Replacement of power transistors SRFH1008 and MRF455

The transistors SRFH1008 and MRF455 are obsolete. The replacement transistor is MS1253-CDN.

Head office		www.codan.com.au		© 17-00214 Issue 1, December 2001		Page 1 of 6	
Codan Limited		Codan Limited		Codan (UK) Ltd		Codan Pty Ltd	
ABN 77 007 590 605		ABN 77 007 590 605		Gostrey House		10660 Wakeman Ct	
81 Graves Street		532 Seventeen Mile Rocks Road		Union Road		Manassas VA 20110	
Newton SA 5074		Sinnamon Park Qld 4073		Farnham Surrey GU9 7PT		USA	
AUSTRALIA		AUSTRALIA		UNITED KINGDOM			
Telephone	+61 8 8305 0311	Telephone	+61 7 3291 6333	Telephone	+44 1252 717 272	Telephone	+1 703 361 2721
Facsimile	+61 8 8305 0411	Facsimile	+61 7 3291 6350	Facsimile	+44 1252 717 337	Facsimile	+1 703 361 3812
asiatech.support@codan.com.au				uktech.support@codan.com.au		ustech.support@codan.com.au

Figure 1: Power amplifier PCB for the 93xx series/9780 and LP transceivers

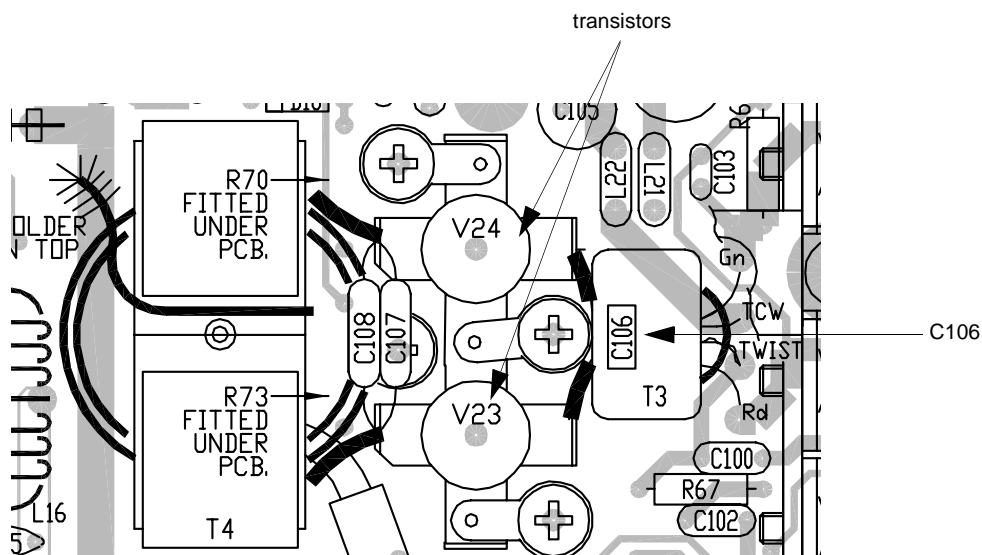
- ❑ Remove the two faulty transistors from the PA PCB (see Figure 1).

- ☐ Replace C106 with a capacitor that has a value of 470 pf.

Later model 93xx series/9780 PAs (Codan part number 08-04963-xxx) may already have the 470 pf capacitor in place. If you are unsure of the value of C106, it is recommended you replace it with a 470 pf capacitor as a precaution.

- ☐ Replace the transistors with MS1253-CDN.
- ☐ Continue from [page 3, Adjusting the driver bias for power amplifiers in 93xx series/9780 and LP transceivers](#).

Figure 2: Power amplifier PCB for the 85xx series/9313/9480 transceivers

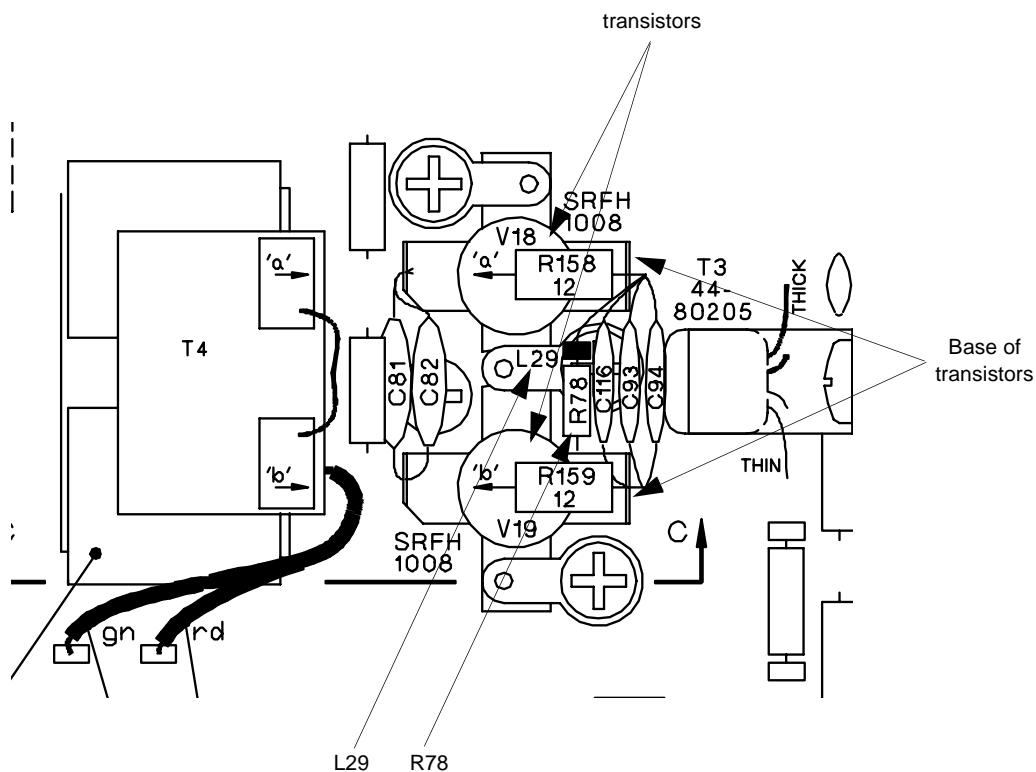
- ❑ Check if there is a resistor/choke (R78/L29) across the base of both transistors on the PA PCB (Codan part number 08-03743-xxx) (see Figure 2).

If R78/L29 is not present, it must be fitted.

Without the resistor/choke in place, spurious oscillations at approximately 4 MHz occur. The resistor/choke network consists of a:

- 12 Ω ¼ W 5% resistor
- ferrite bead placed on one leg of the resistor with a small amount of silastic to stop any movement

- ☐ Replace the transistors with MS1253-CDN (see Figure 2).
- ☐ Continue from [page 5, Adjusting the output bias in all transceivers](#).

Figure 3: Replacing the fuse

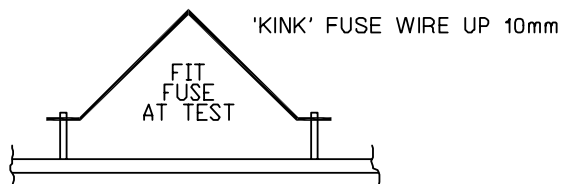
- ❑ If the **PA O/P** fuse is broken, do the following:
- Replace the **PA O/P** fuse with two strands (2×0.2 mm TCW) taken from a piece of 7×0.2 mm cable.
 - Solder the wire ends to the stakes as shown in [Figure 3](#).
 - Kink the wire up 10 mm to form an inverted V as shown in [Figure 3](#).
